# Access Compliance Report Public Rights-of-Way (Curb Ramps)

| Main Street: DORRANCE_DR |                              | Cross Street: PERCHERON_DR |                        | Location:       | NE |
| ADA ID: RPRK211112124937 | Ramp Type: Type 4 - Parallel | Initial Pass/Fail: Fail    | Overall Compliance: No | Severity Score: | 16 |

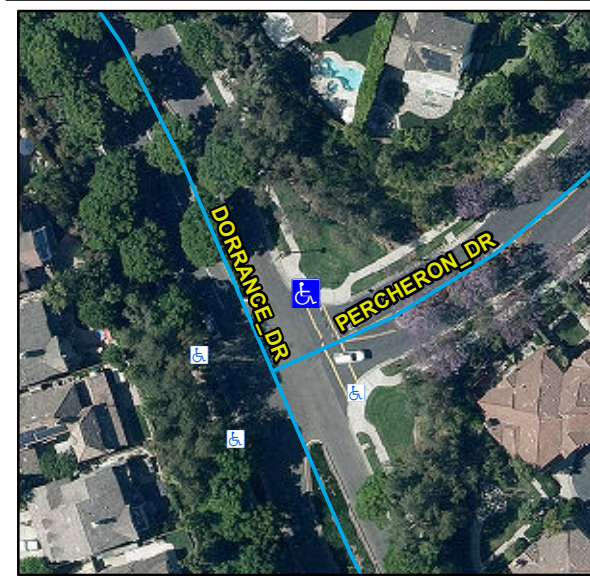
| Compliance | Description                   | Data       | Compliance | Description                   | Data |
|------------|-------------------------------|------------|------------|-------------------------------|------|
| Yes        | Ramp Cross Slope LT (%)       | 0.5        | No         | Ramp Cross Slope RT (%)       | 2.3  |
| N/A        | Gutter Cross Slope (%)        | N/A        | No         | Perpendicular Joint Present   | No   |

**Remove & Replace Curb Ramp With Two New Directional Ramps or Equivalent.**

**R204.3, R304.5.3, STD 1115**
